RICOH**Technical Bulletin****No. RTB-003**

SUBJECT: Corona Casing Cleaning

FROM: Copier Technical Support Section

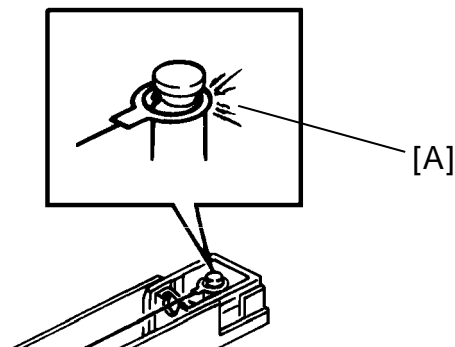
If toner or some other material accumulates inside the corona end block especially inside the hook groove [A], it may cause an electrical leak under humid conditions.

Section	Action at EM/PM
Casing	Clean with water first and with alcohol if toner still remains.
End Block	Clean with a blower brush and then with alcohol.

Windows95 after update

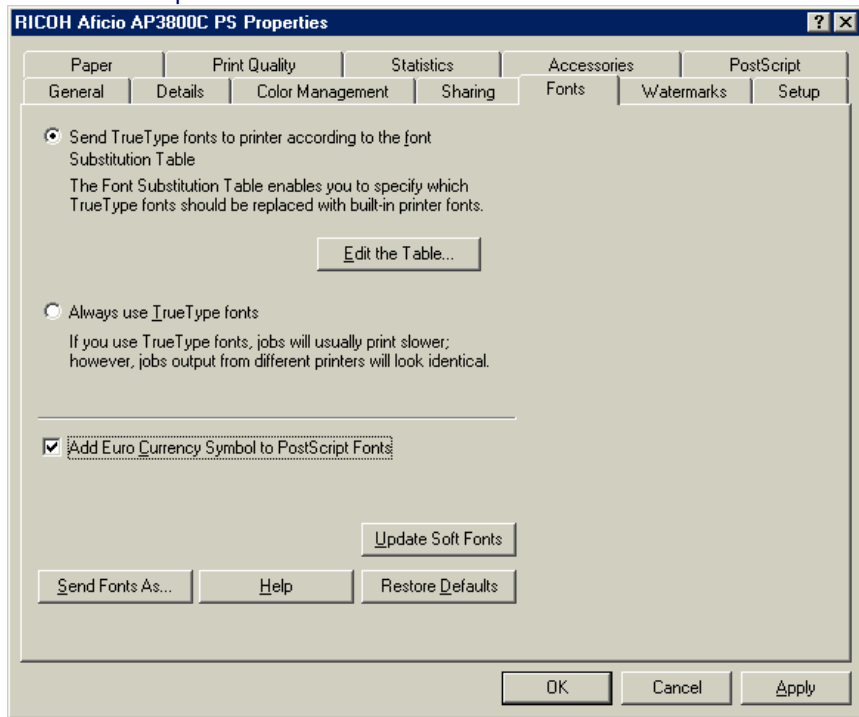
Check "Add Euro Currency Symbol to PostScript Fonts". (Before update, the check box doesn't work.)

Windows 2000

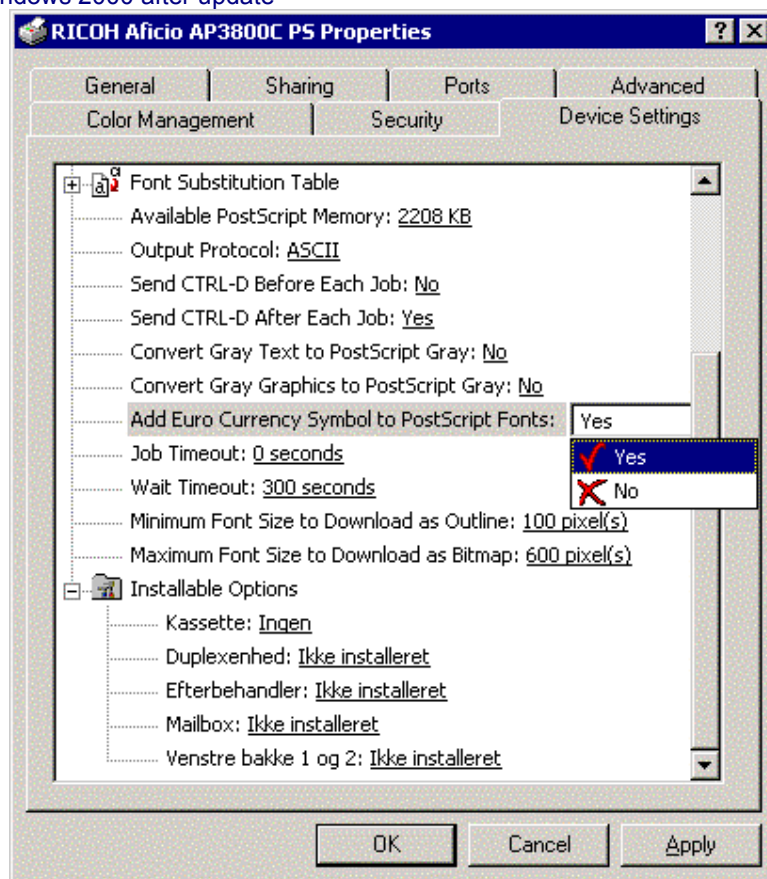
Update the printer driver to v5.5.2 or later.

Check "Add Euro Currency Symbol to PostScript Fonts".
